Retrofitting Trelleborg Engine Mounts to Pre-GHG17 Heavy-Duty Engines

TSB-01-102-FTL

Last Revision Date: 2026-05-07

Fig. 1, Rear Engine Mounts by Manufacturer

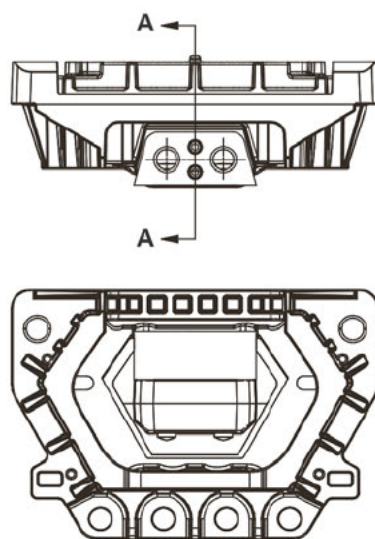
Vehicles built prior to GHG17 use engine mounts produced by Parker LORD. See Fig. [1](#). If the rear LORD engine mounts are not available from the Parts Distribution Center (PDC), the new version from Trelleborg can be adapted to replace the original mounts. It is recommend to replace both rear and front mounts, if one LORD engine mount is being replaced with a Trelleborg engine mount. In some installations, the original mount is an assembly that includes an additional spacer. See Fig. [2](#). In these cases, the spacer needs to be removed from the original assembly and installed between the new mount and the engine leg. For parts, see Table . Follow the steps below to convert the rear engine mounts. The front mounts are interchangeable.

❗ Important: Do not use the fasteners for the LORD rear engine mount for the Trelleborg rear engine mount.

Fig. 2, LORD Engine Mount Assemblies with Spacers

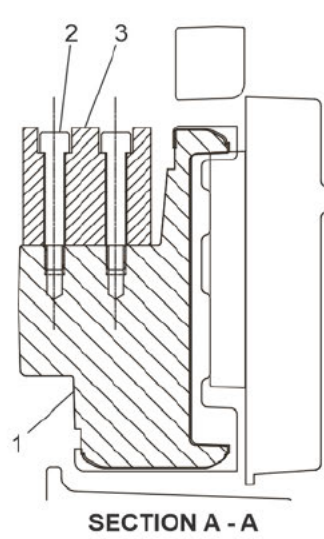
1. Engine Leg Mounting Boss
2. Spacer Fasteners (not used for the Trelleborg installation)
